DART AEROSPACE LTD	Work Order:	164201
Description: Crosstube Assembly	Part Number:	D407-667-145
Inspection Dwg: D407-667-145 Rev: C		Page 1 of 2

DRAWING NO. **D407-667-145** REV. C
SHEET 1 OF 4

TITLE **CROSSTUBE ASS'Y (407 HIGH FWD)** SCALE **NTS**

DRAWING NO. D407-667-145	TITLE CROSSTUBE ASS'Y (407 HIGH FWD)	REV. C	DART AEROSPACE LTD ENGINEERING ORDER		D.E.O. NO. D407-667-145-C-1	SHEET NO. SHEET 1 OF 1	SCALE NTS
DRAWN <i>90</i>	CHECKED <i>ASS</i>	MFG. APPR. <i>18</i>	APPROVED <i>WD</i>		DE APPR. <i>11</i>		
DATE 11.07.15	DATE 11.07.22	DATE 11.07.22	DATE 11/07/22		DATE 11.07.21

DETAIL P
BONDING STRAP INSTALLATION 2 PL

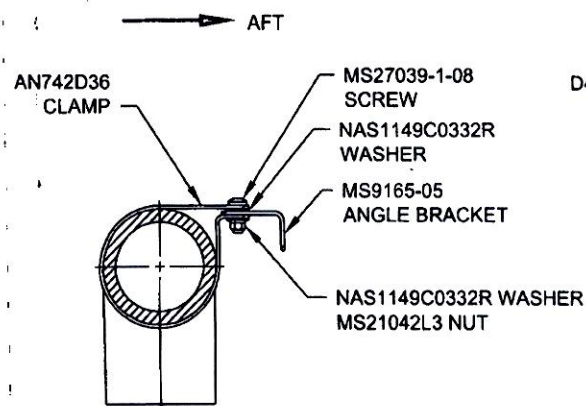
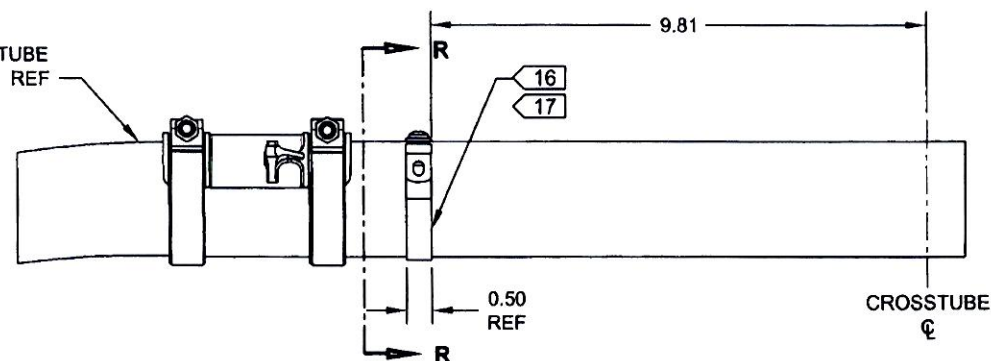
ADD ELECTRICAL GROUNDING STRAP

ITEM	QTY -145	PART NUMBER	DESCRIPTION
1	X	D407-667-145	CROSSTUBE ASSEMBLY (407 HIGH FWD)
10	2	AN742D36	CLAMP
11	2	MS9165-05	ANGLE BRACKET
12	2	MS21042L3	NUT (OR MS21042-3)
13	2	MS27039-1-08	SCREW
14	4	NAS1149C0332R	WASHER (OR AN960C10L)

- 16) MASK AREA UNDER CLAMP PRIOR TO PAINTING
- 17) SEAL EDGES WHERE AN742D36 CLAMP MEETS WITH THE CROSSTUBE USING SIKAFLEX-241/-291 OR MIL-S-8802 CLASS B2 OR PROSEAL 890 SEALANT
- 18) PERFORM RESISTANCE CHECK TO ENSURE MAX RESISTANCE IS 10 MILLIOHMS
